TOWN OF WILTON
ADDENDUM NO. 2

RFP #2022-09

**Request for Proposal to Replace Lovers
Lane Bridge - Bridge #04975**

ADDENDUM NO. 2

DRAWING NO. S-13
 SHEET NO. 04.13.A2

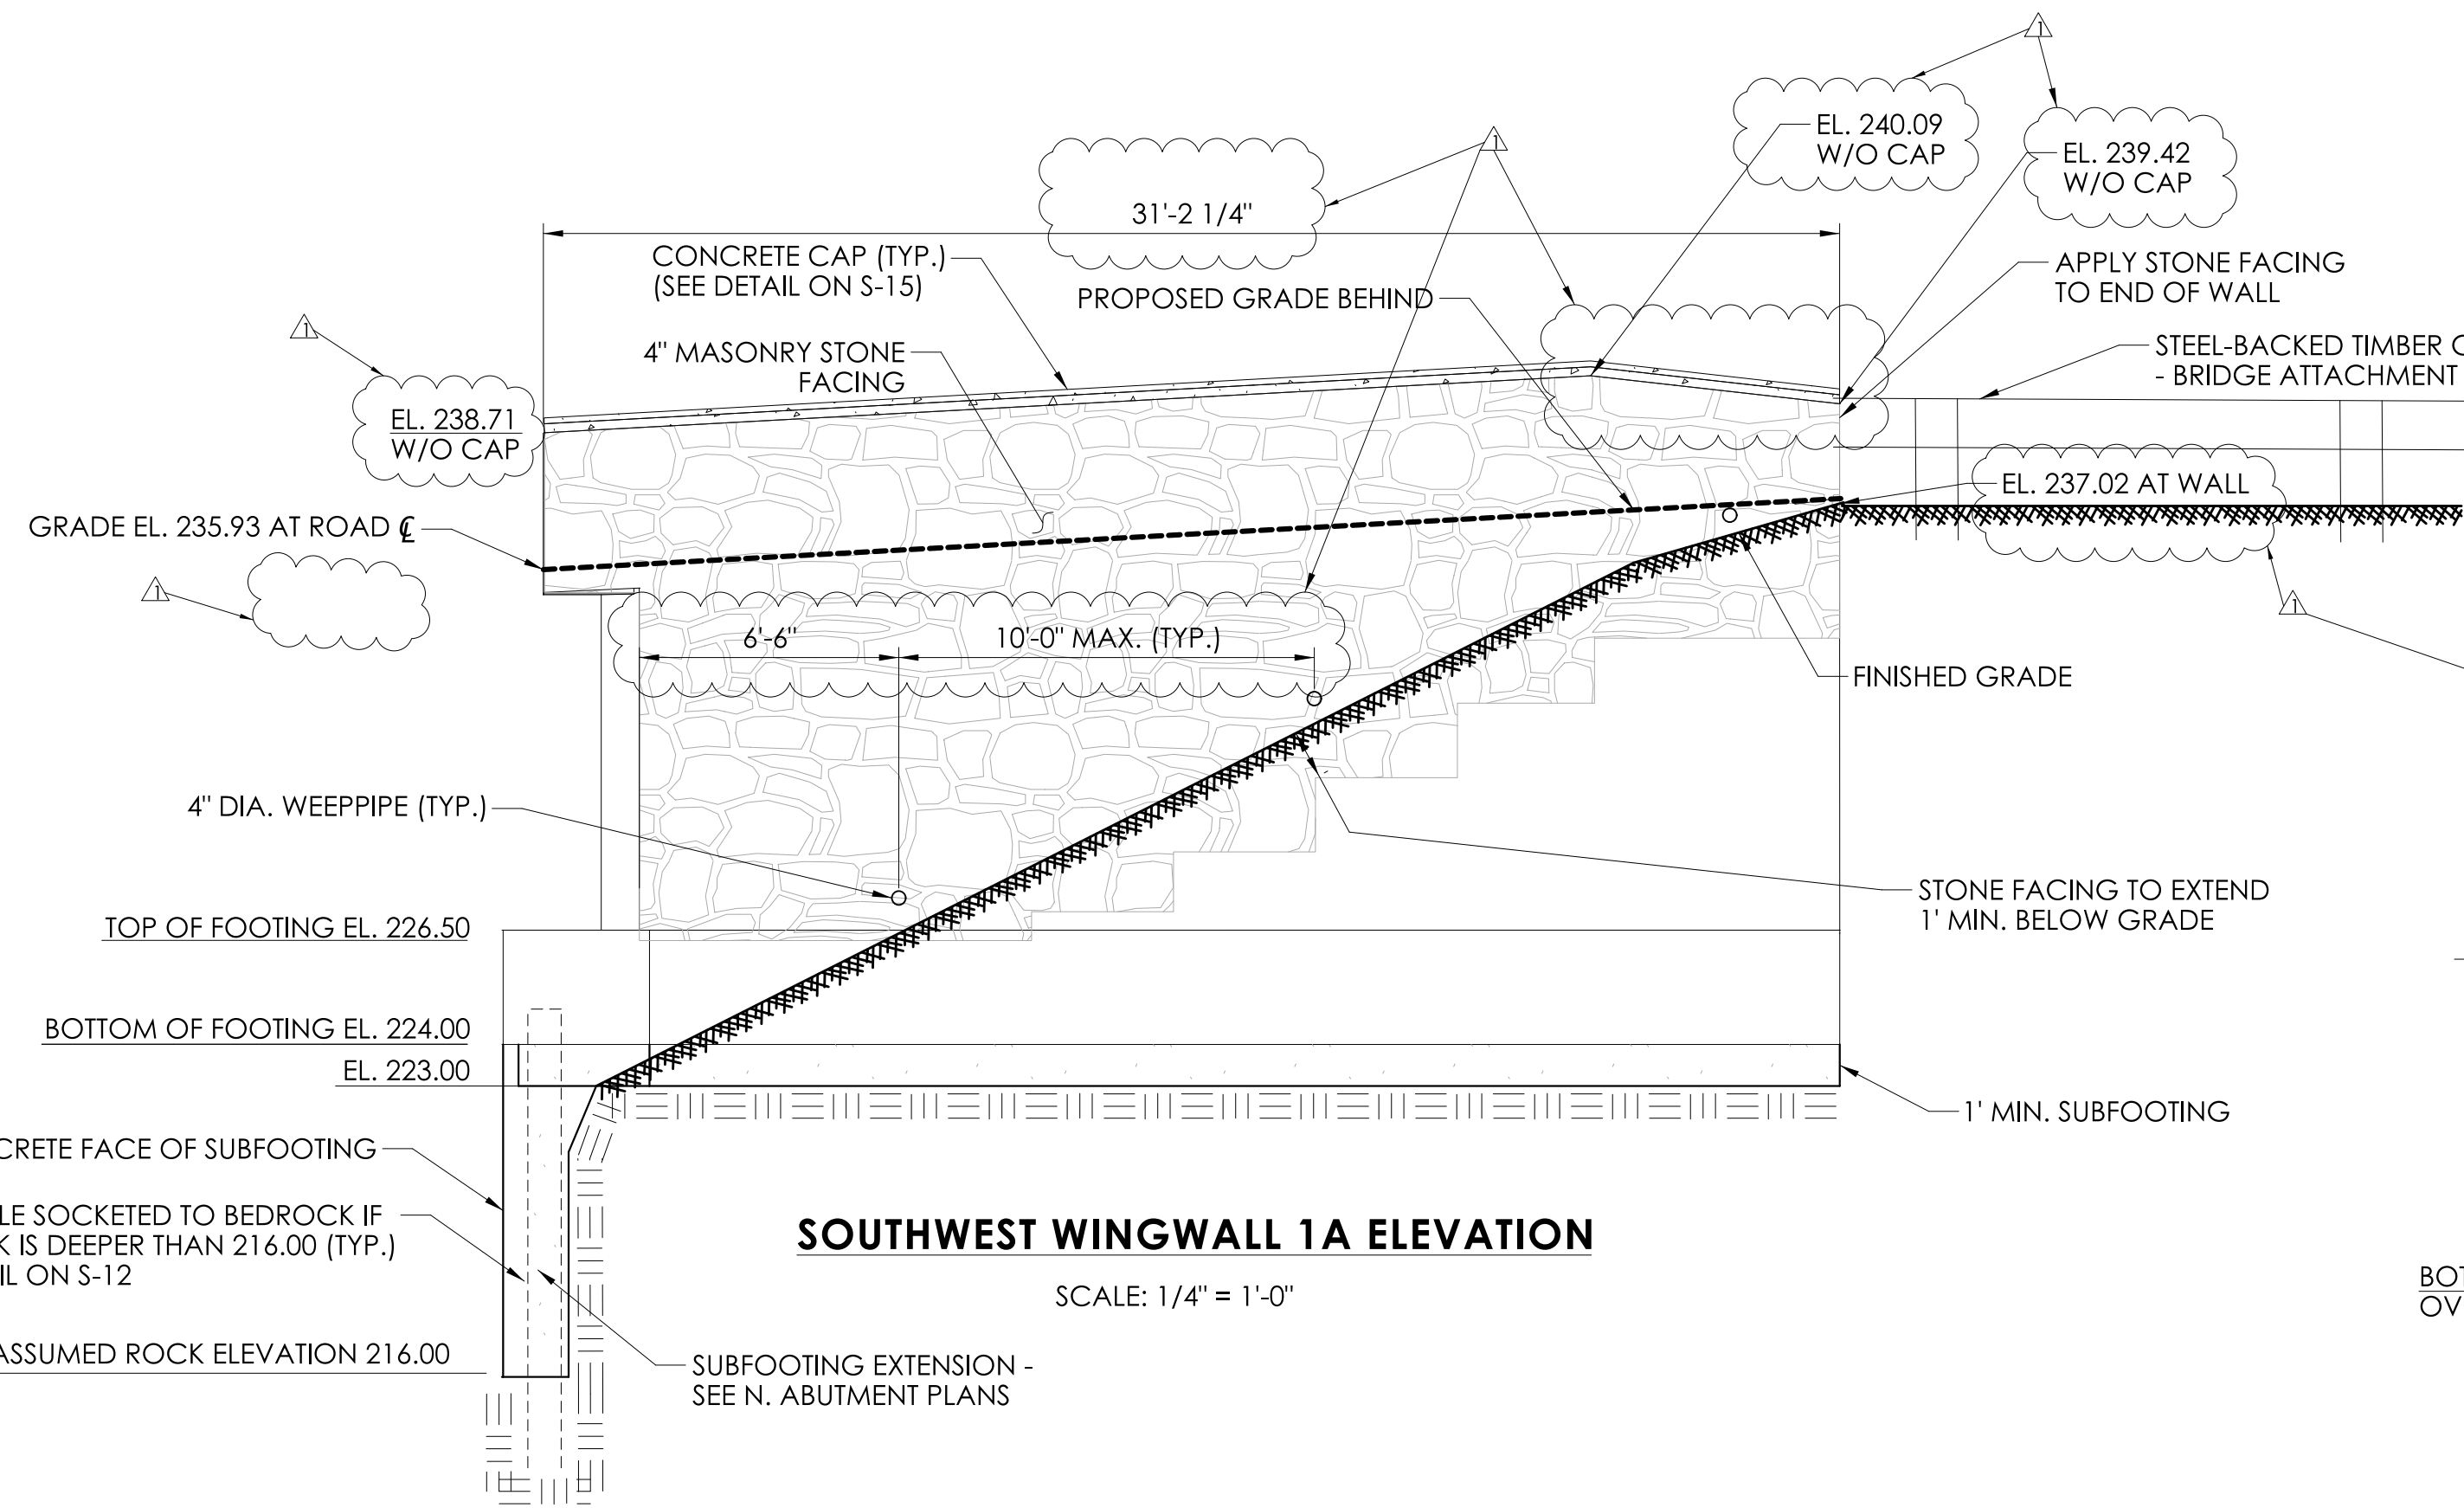
REV.	DATE	REVISION DESCRIPTION
1	12/15/22	REVISE WINGWALLS

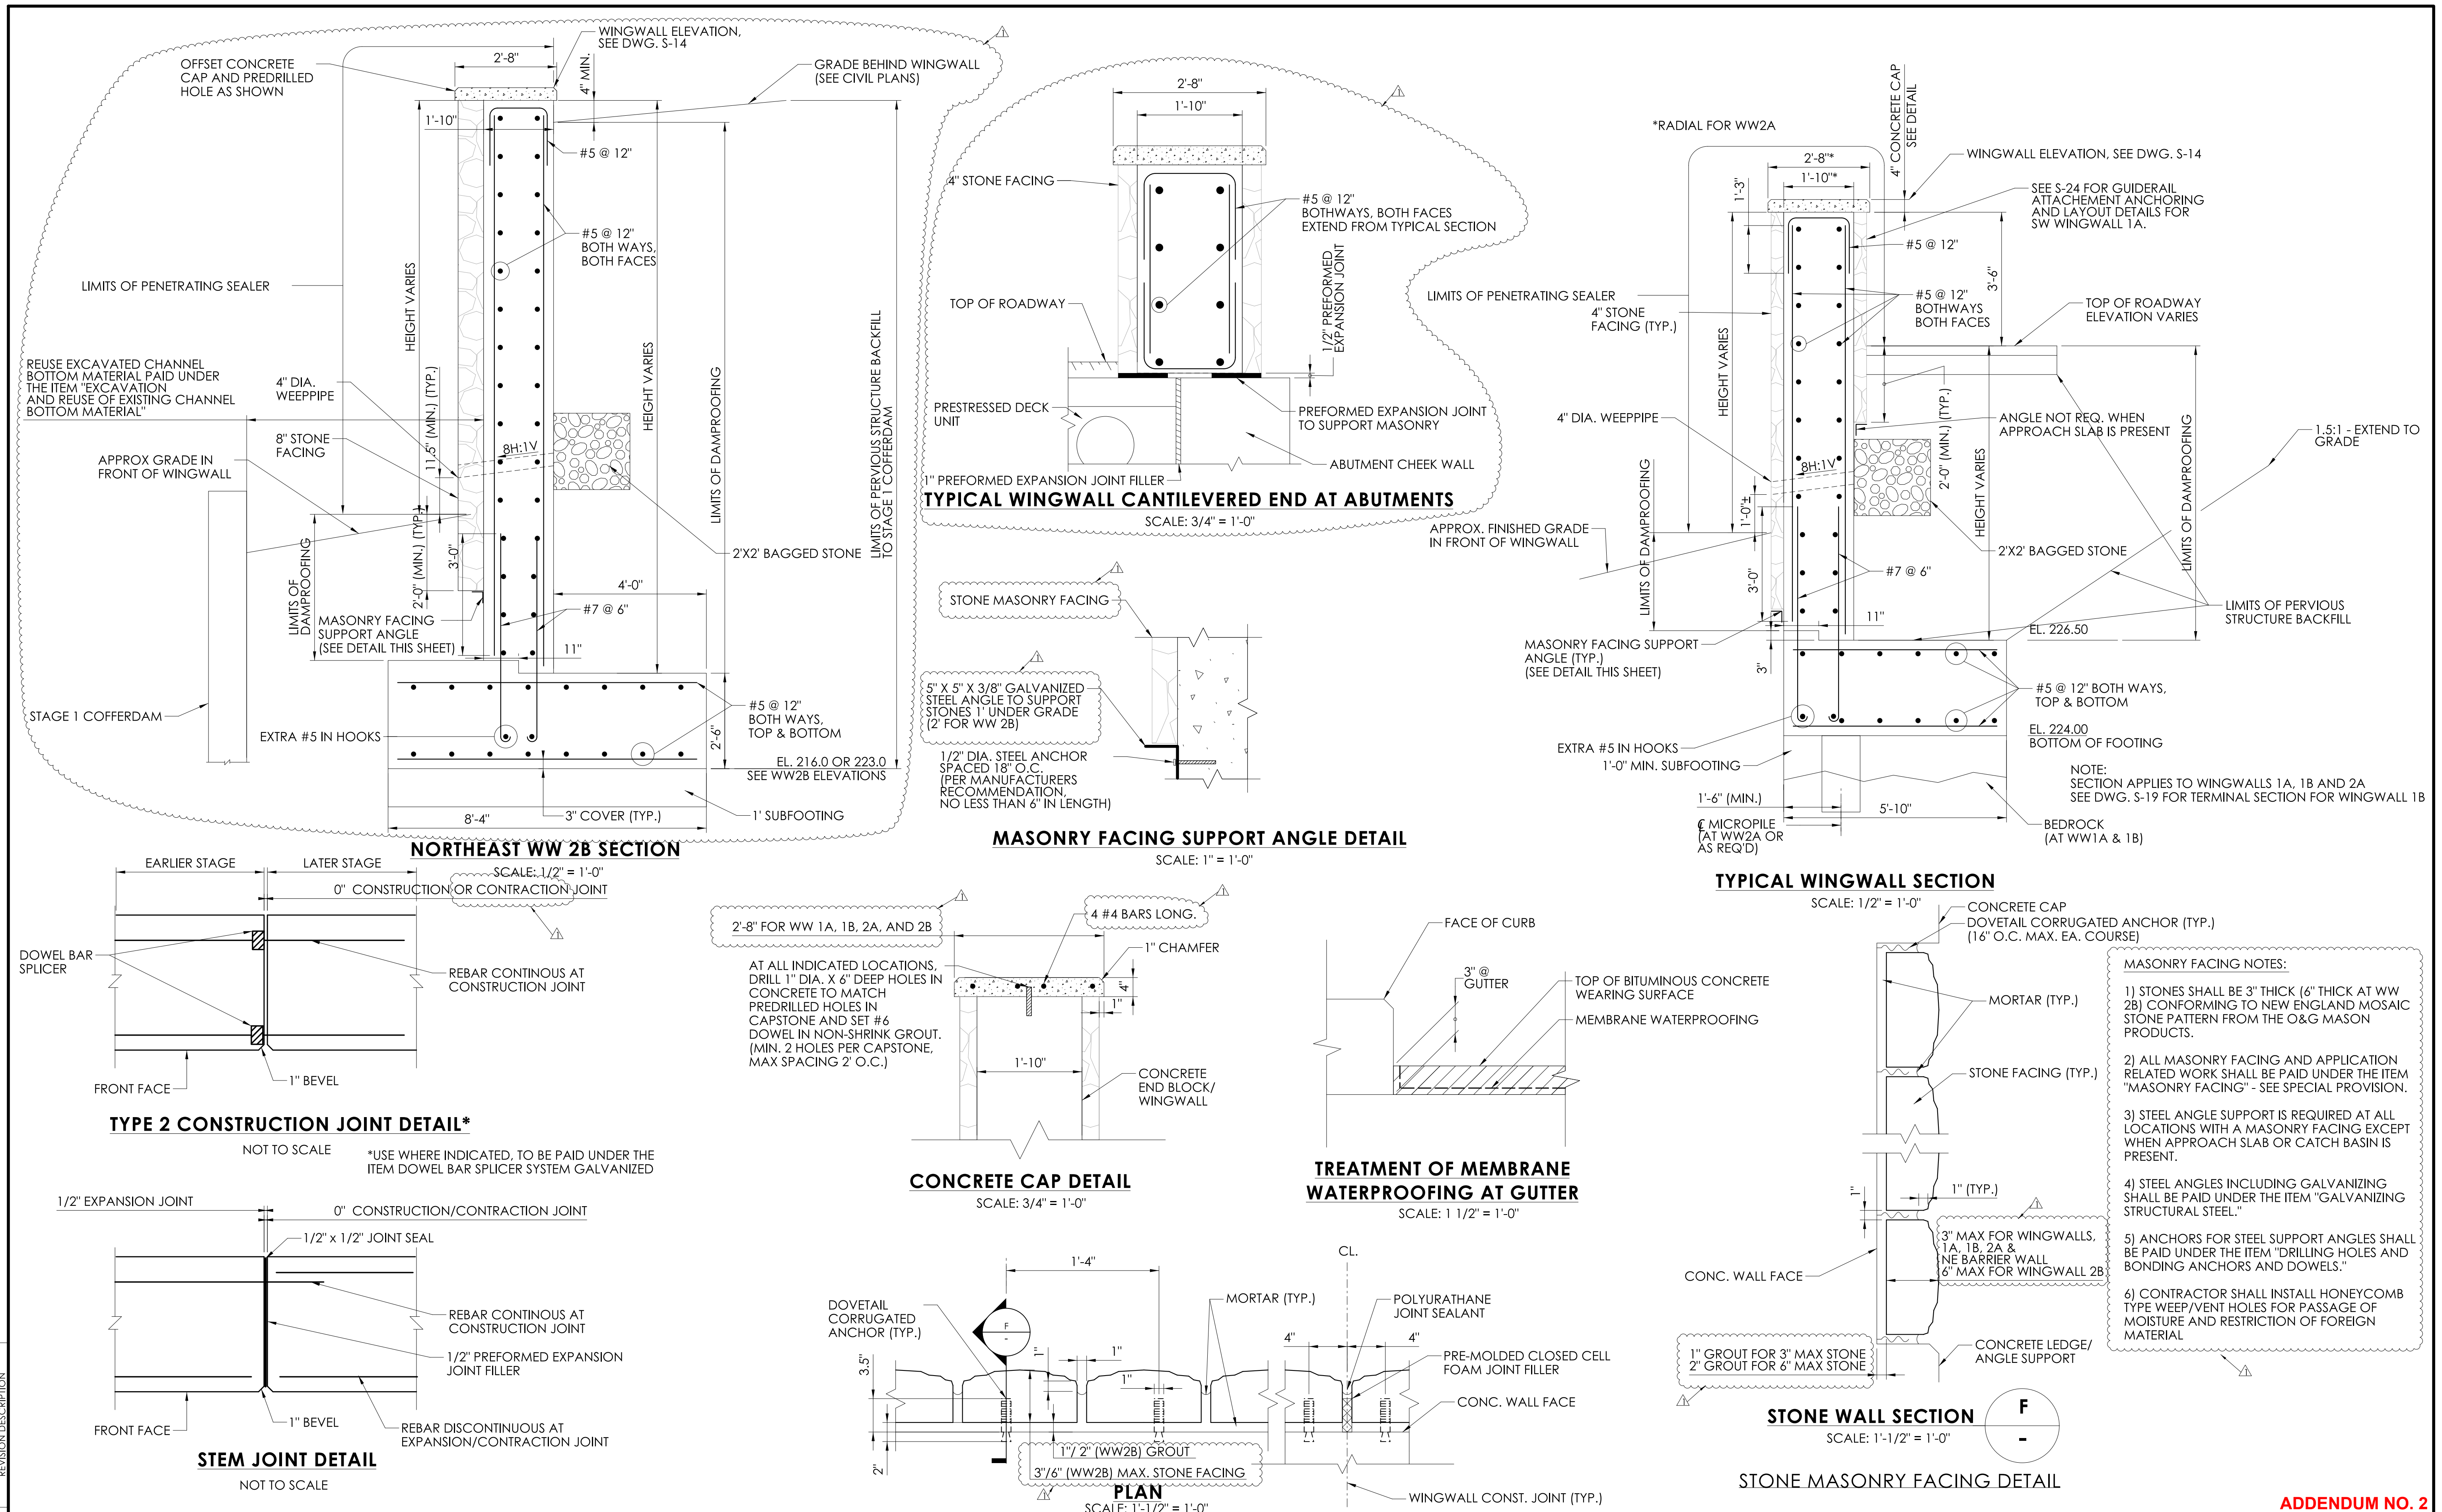
REV.	DATE	DESCRIPTION
1	12/15/22	WW 2B ROCK FACING THICKNESS

- MASONRY FACING NOTES:**
- 1) STONES SHALL BE 3" THICK (6" THICK AT WW 2B) CONFORMING TO NEW ENGLAND MOSAIC STONE PATTERN FROM THE O&G MASON PRODUCTS.
 - 2) ALL MASONRY FACING AND APPLICATION RELATED WORK SHALL BE PAID UNDER THE ITEM "MASONRY FACING" - SEE SPECIAL PROVISION.
 - 3) STEEL ANGLE SUPPORT IS REQUIRED AT ALL LOCATIONS WITH A MASONRY FACING EXCEPT WHEN APPROACH SLAB OR CATCH BASIN IS PRESENT.
 - 4) STEEL ANGLES INCLUDING GALVANIZING SHALL BE PAID UNDER THE ITEM "GALVANIZING STRUCTURAL STEEL."
 - 5) ANCHORS FOR STEEL SUPPORT ANGLES SHALL BE PAID UNDER THE ITEM "DRILLING HOLES AND BONDING ANCHORS AND DOWELS."
 - 6) CONTRACTOR SHALL INSTALL HONEYCOMB TYPE WEEP/VENT HOLES FOR PASSAGE OF MOISTURE AND RESTRICTION OF FOREIGN MATERIAL

FRAMING PLAN
SCALE: 1/4" = 1'-0"

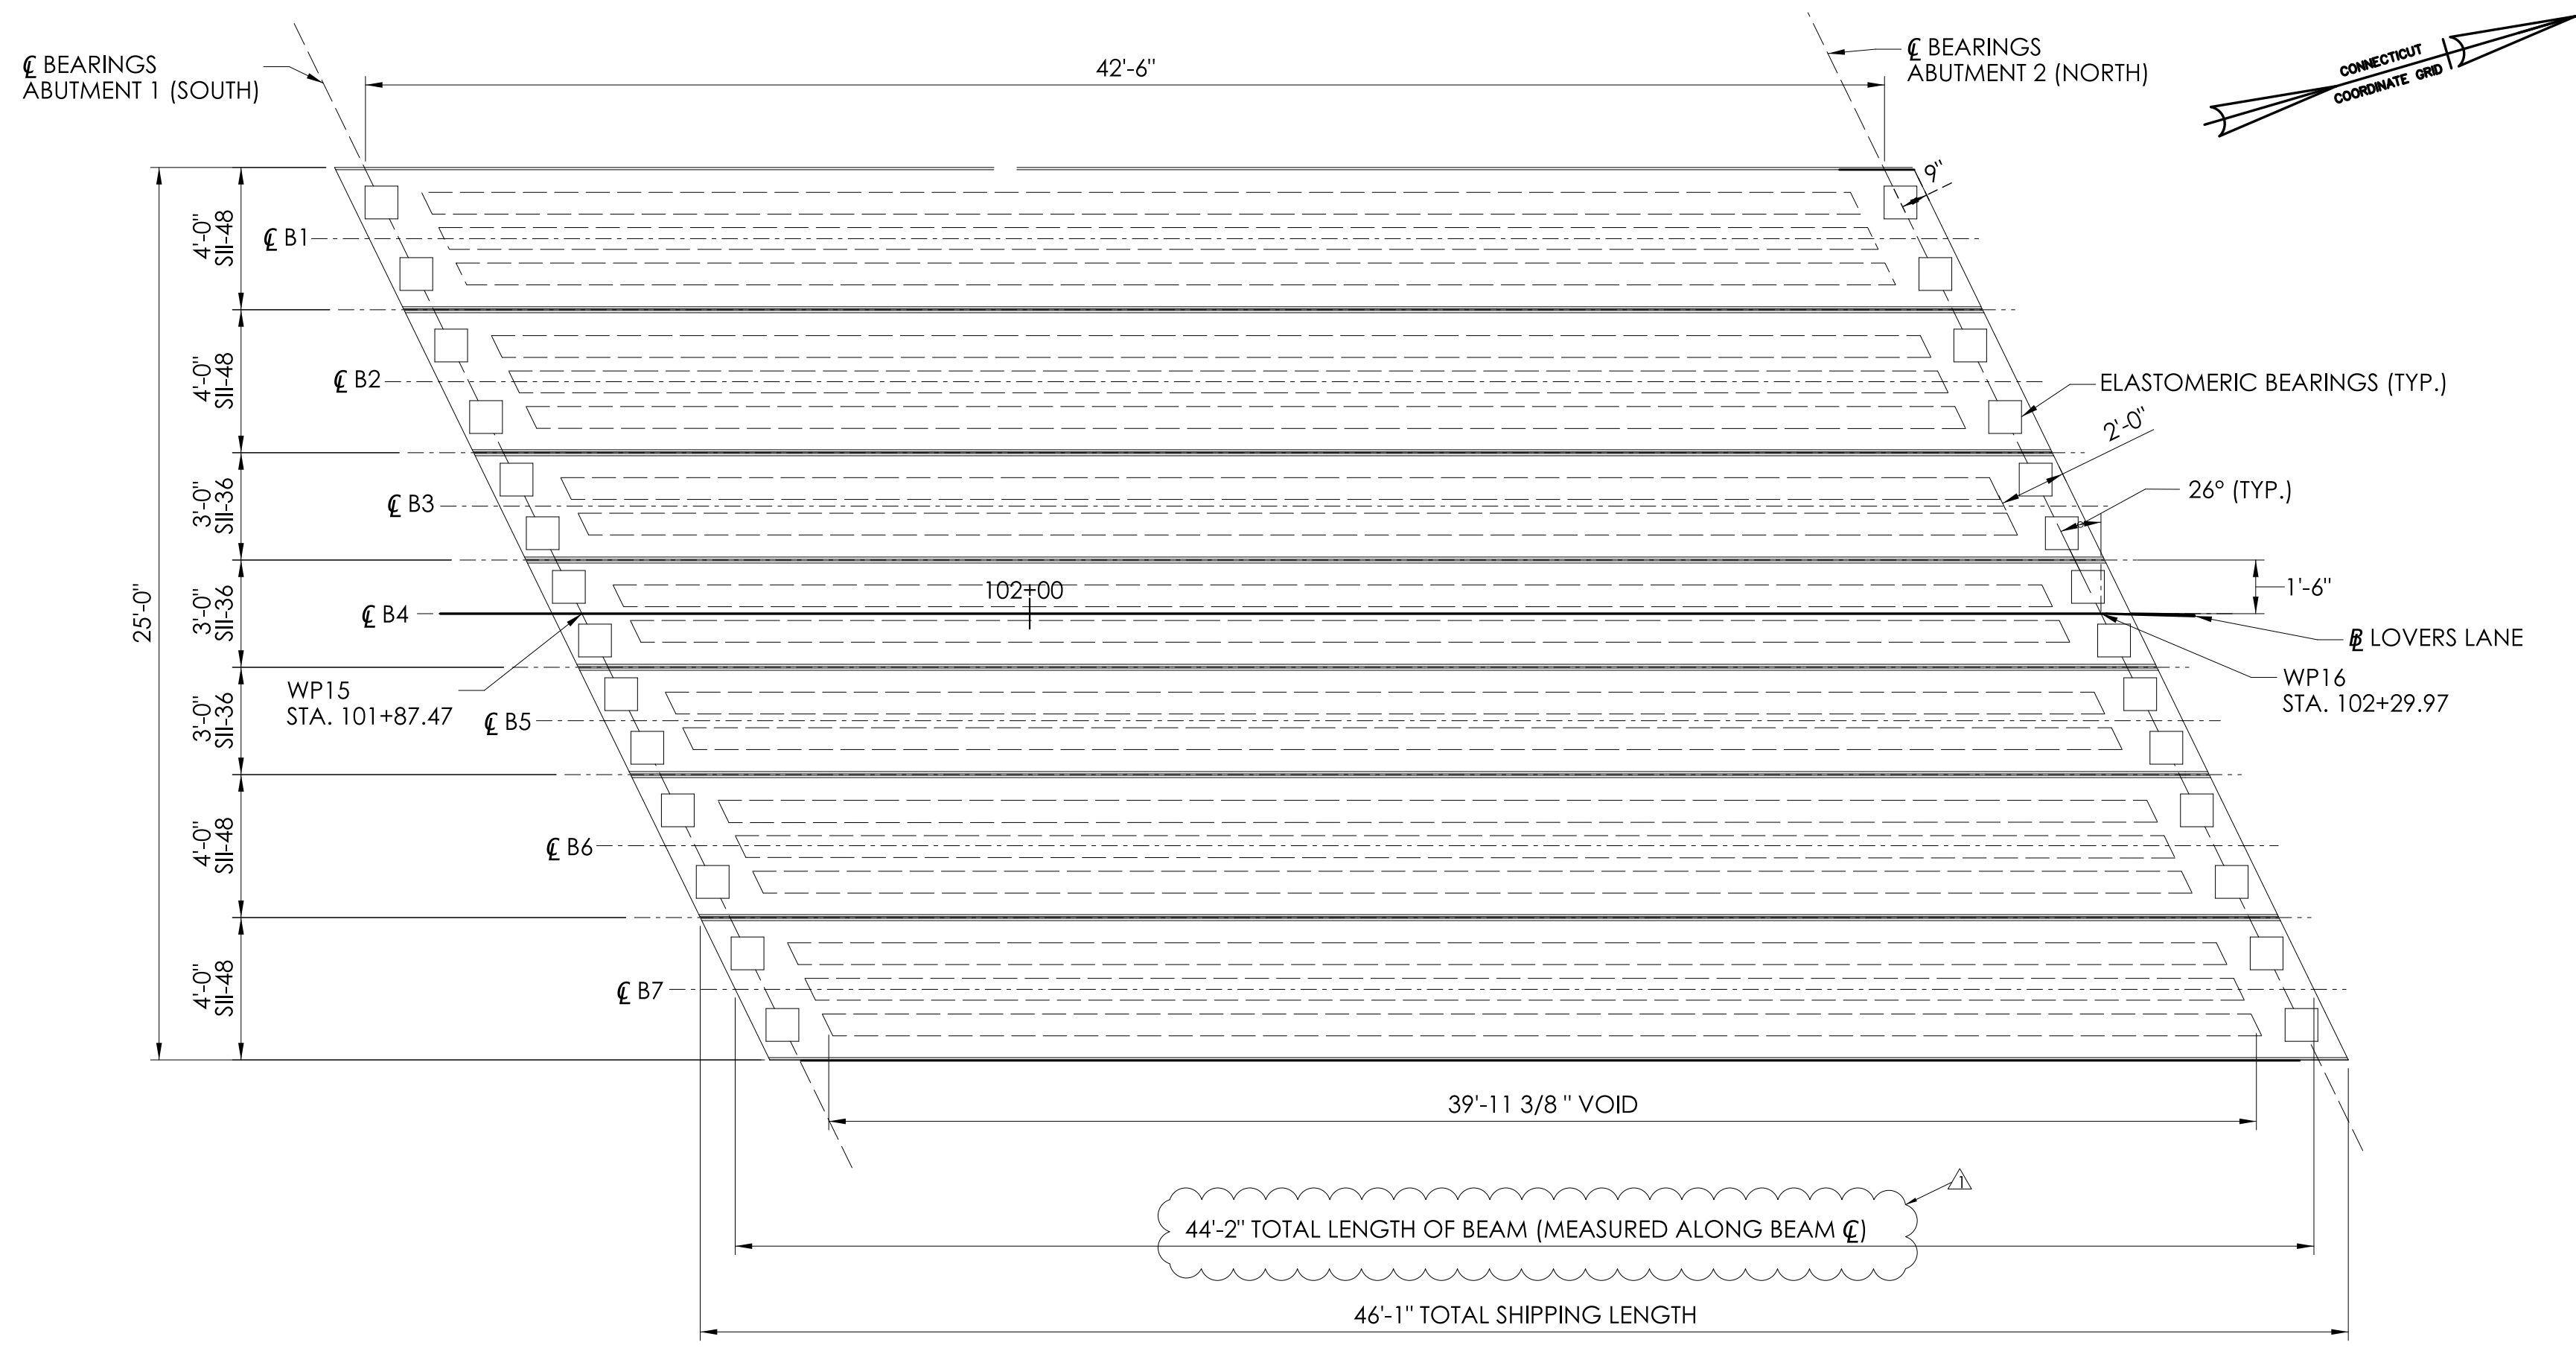
REV.	DATE	DESCRIPTION
1	12/15/22	UPDATE FRAMING PLAN
